# City Planning Department

## Memo

To: Cranston City Plan Commission  
From: Joshua Berry, AICP - Senior Planner / Administrative Officer  
Date: January 28, 2022  
Re: **Dimensional Variances @ 15 Usher Avenue & 0 Midvale Avenue**

**Owner/App:** Donald B. Coletti  
**Location:** 15 Usher Ave (AP 11 Lot 2524) and 0 Midvale Avenue (AP 11 Lot 2523)  
**Zone:** A-6 (Single-family dwellings on 6,000 ft<sup>2</sup> minimum lots)  
**FLU:** Single Family Residential 7.26 to 3.64 units/acre

### SITE PLAN

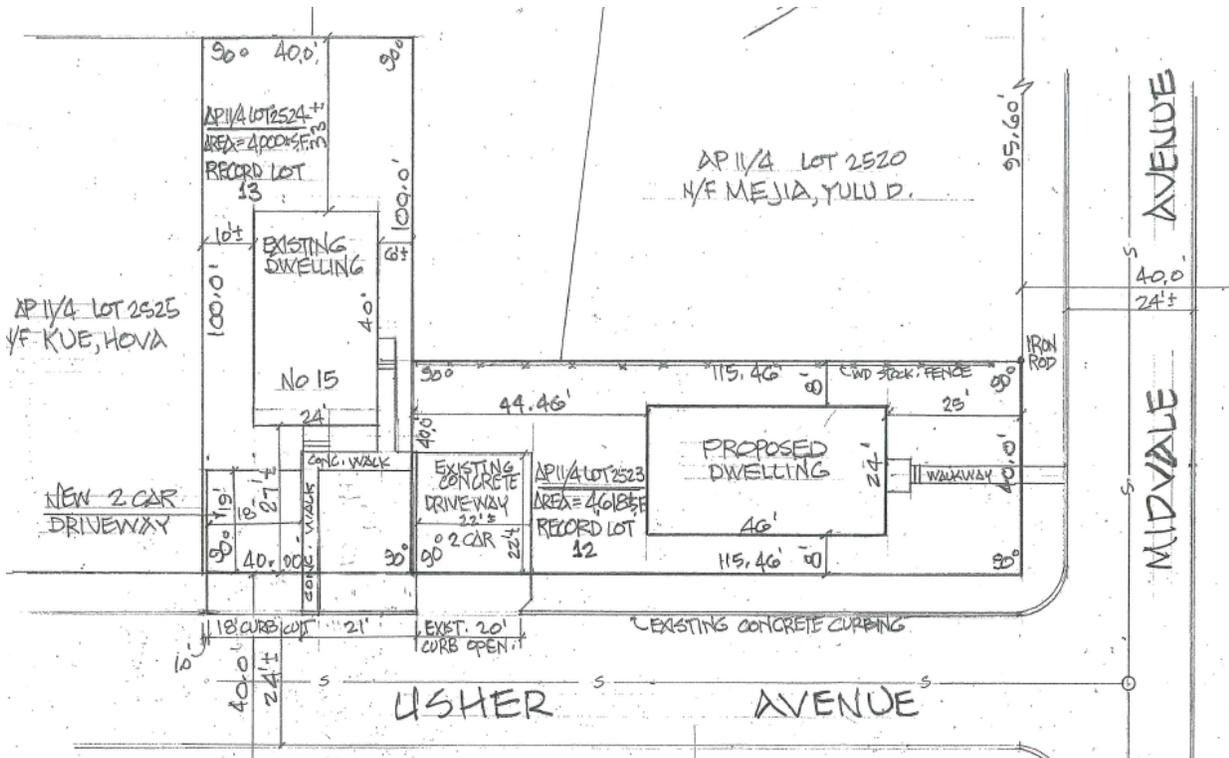
The more impactful aspect of the application is the request to allow a new single-family home to be built on AP 11 Lot 2523, a corner lot that is 40' x 115.46'. 25' front setbacks are required from Usher Avenue and Midvale Avenue. The plan shows that the proposed new residence complies with the 8' side yard setback in A-6 zones, but due to the lack of width, this pushes the side of the 24' wide house 17' into the front yard setback on Usher Ave. However, Code Section 17.20.090 (F) states that a reduced side setback of 5' shall apply when the frontage is less than 50'. In order to reduce the encroachment into the front setback to the least amount necessary, **Planning staff recommends that the applicant move the building 3' closer to the interior side lot line thereby reducing the encroachment into the front setback from 17' to 14'.**

# ELEVATIONS

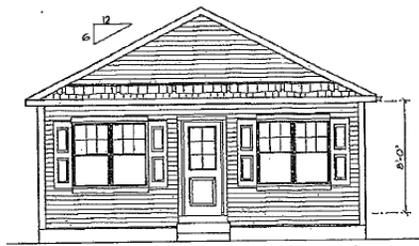
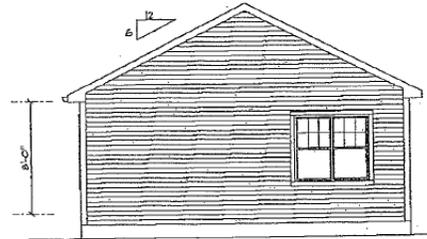
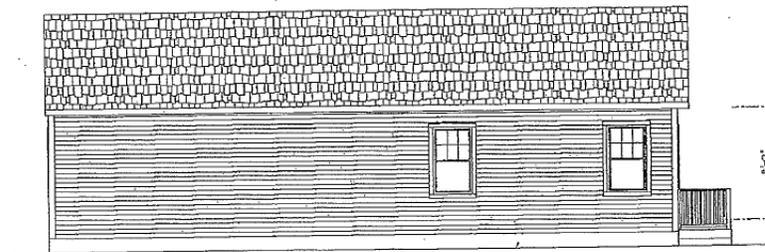
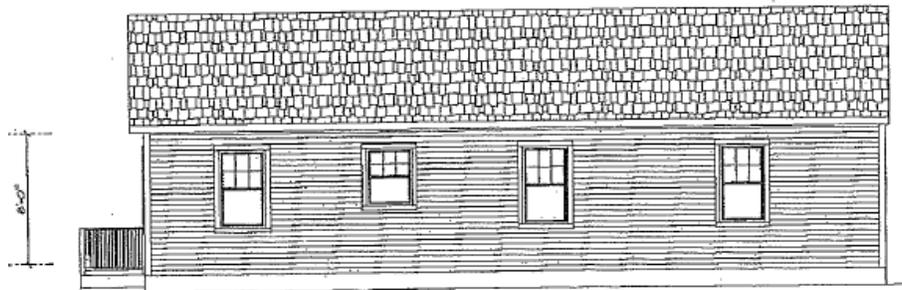
5. The Comprehensive Plan Land Use Element; Principle 4 reads: "*Protect and stabilize existing residential neighborhoods by basing land use decisions on neighborhood needs and quality of life. Protect the natural, historic and visual resources that define the neighborhoods*" (p. 34). The side of the proposed single-family residence would encroach 17' into the required 25' front setback. It is inconclusive whether proposed encroachment would negatively impact the visual resources that define the neighborhood.

The Comprehensive Plan Land Use Element; Principle 4 reads: “*Protect and stabilize existing residential neighborhoods by basing land use decisions on neighborhood needs and quality of life. Protect the natural, historic and visual resources that define the neighborhoods*” (p. 34). A nearly identical circumstance exists one block west of the subject site, without measurable negative affect, yet without the benefit of a public hearing and testimony from the neighbors, staff does not conclusively assert that this would not have any negative visual impacts. **Staff finds that the reduced lot area and frontage do NOT have a negative impact on the visual resources that define the neighborhood, but it remains inconclusive whether the encroachment into the front setback would negatively impact the visual resources that define the neighborhood.**
